BACK DOOR WINDOW REGULATOR RUST

PRODUCTION EFFECTIVE:

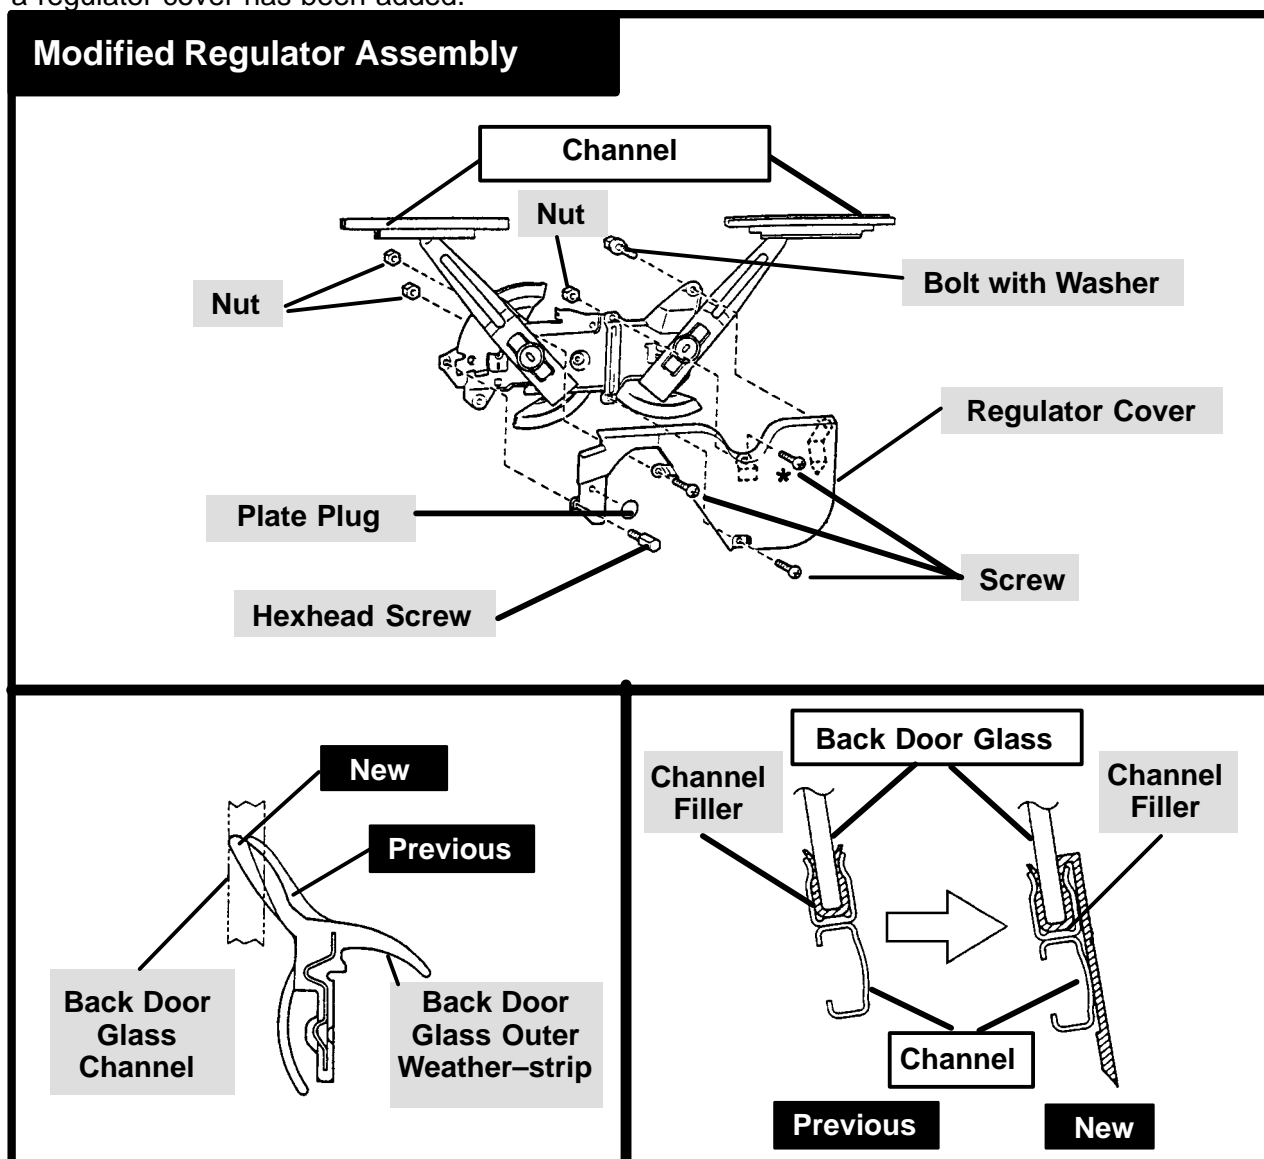
To improve anti-rust performance of the back door window assembly (with rear window defogger), the shapes of the back door glass outer weather-strip and channel filler have been changed and a regulator cover has been added.

NOTE: Installation of the screw identified by an * can be simplified by pushing down on the regulator cover (near the threaded screw hole) during installation.
